# PCN-20190111 TE0841-02-\* SPI Flash Change

<b>Company</b>	Trenz Electronic GmbH
<b>PCN Number</b>	PCN-20190111
<b>Title</b>	TE0841-02-* SPI Flash Change
<b>Subject</b>	BOM change
<b>Issue Date</b>	2019-07-15

### #1 Change SPI Flash from N25Q512A11G1240E to MT25QU512ABB8E12-0SIT

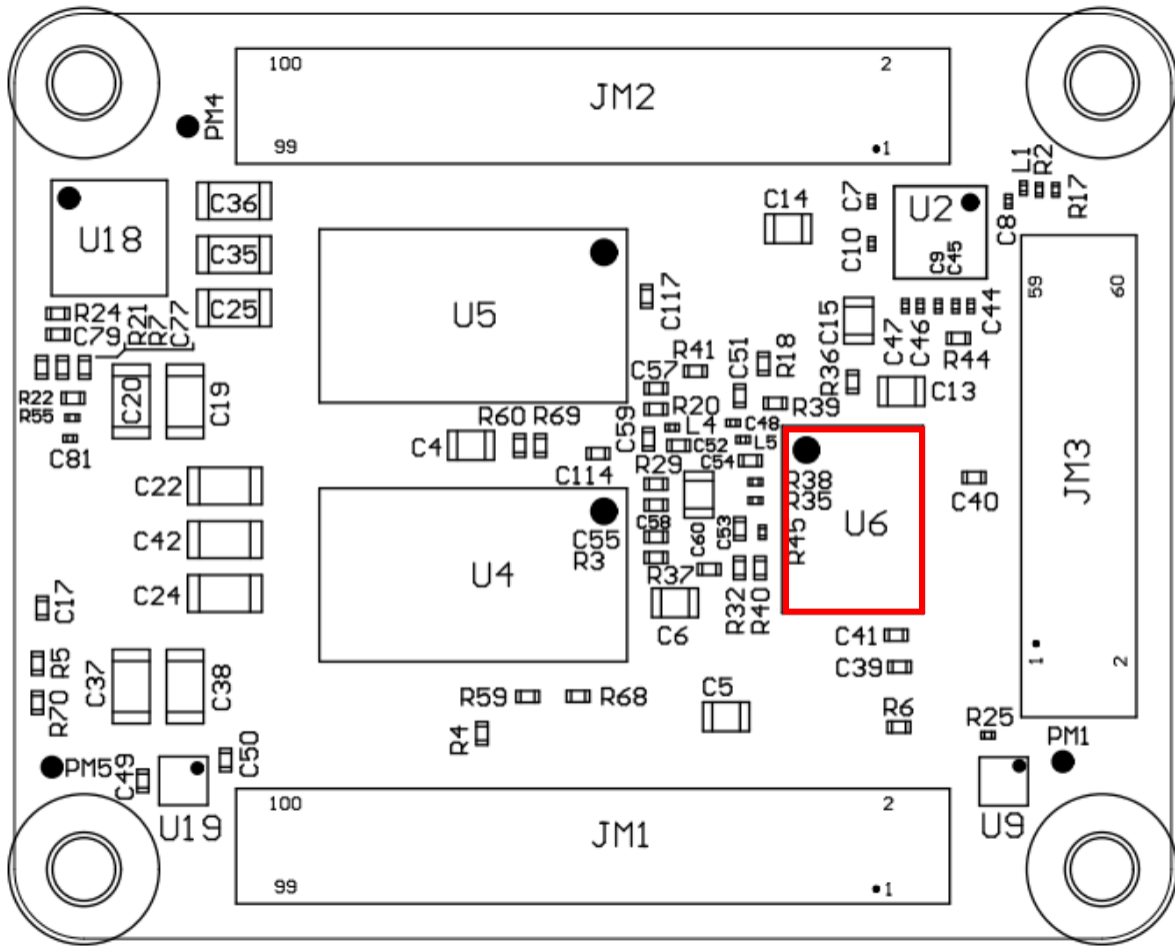
**Type:** BOM change

**Reason:** N25Q512A11G1240E became obsolete.

**Impact:** None. Both have same JEDEC ID BB20h and manufacturer ID 20h.

Locate Flash (U6) on top side of PCB:

old	new
<b>N25Q512A11G1240E</b>	<b>MT25QU512ABB8E12-0SIT</b>
 <p>25Q256A 11E40 Ⓜ 99 MYS 99627A1800</p>	 <p>HTH 8KA17 RW193 MT</p>
